From: drainage <drainage@midsussex.gov.uk>
Sent: 24 February 2026 12:55:31 UTC+01:00
To: "Anna Tidey" <anna.tidey@midsussex.gov.uk>
Cc: "drainage" <drainage@midsussex.gov.uk>
Subject: 2026.02.24 Re: DM/26/0157 - 66 Meadow Drive Lindfield Haywards Heath West Sussex RH16 2RR

We understand the proposed application is for a single storey front, side and rear extensions.

The Flood Risk Assessment provided by the Applicant (Reference: Steve Bull) has been reviewed and we would comment as follows:

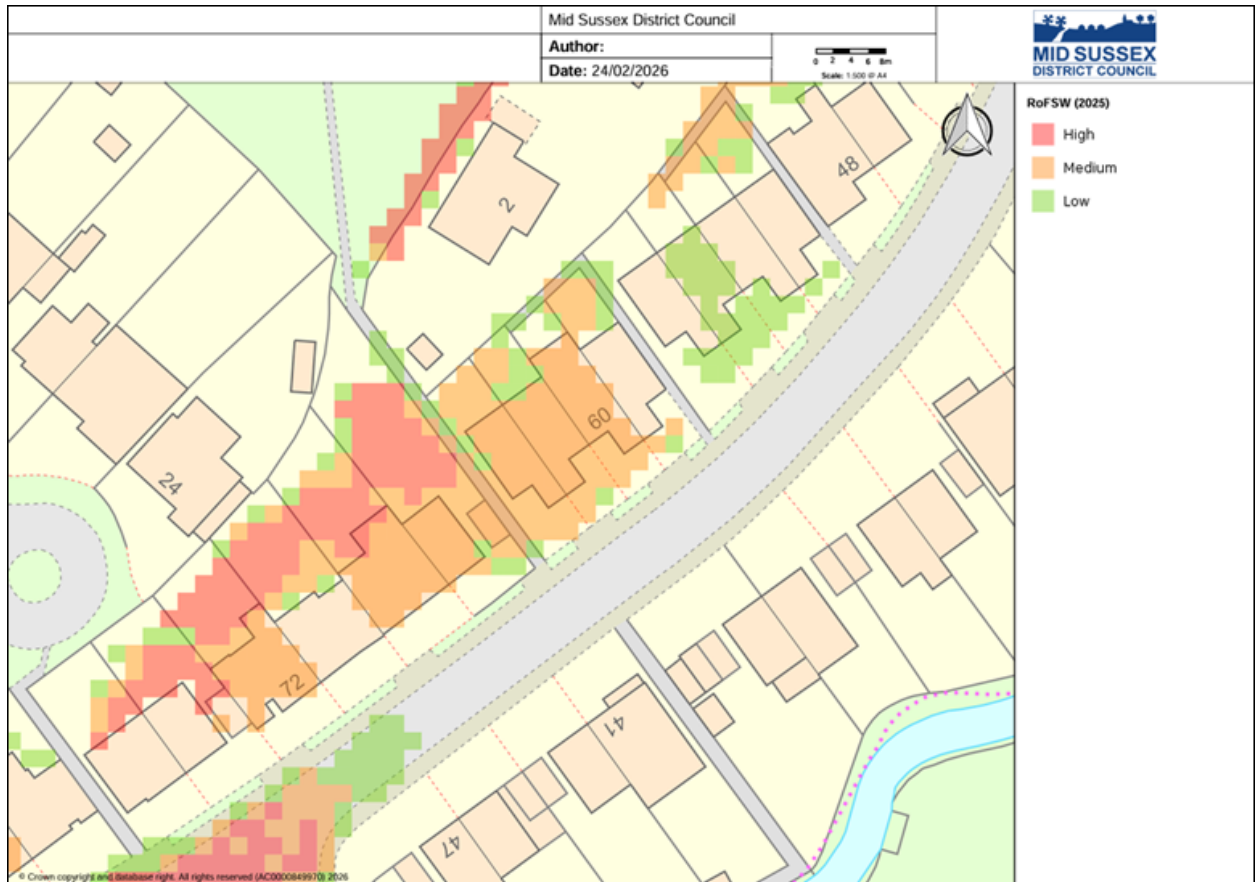
However, the Environment Agency's Risk of Flooding from Surface Water (RoFSW) mapping indicates that the site is shown to be at very low to high surface water flood risk (comparable to Flood Zones 1 to 3b). The area of high surface water flood risk is associated with a flow path running along the rear of the property.

The applicant has failed to demonstrate that the proposed development is located outside of the 1 in 30-year surface water flood extent. In the absence of such evidence, and based on the latest flood risk mapping, part of the site is considered to fall within the equivalent of Flood Zone 3b (functional floodplain).

The Flood Risk and Drainage Team, therefore, **Objects** to the proposed development as per the Environment Agency's standing advice for minor extensions; development within the 1:30 flood extent is not permissible.
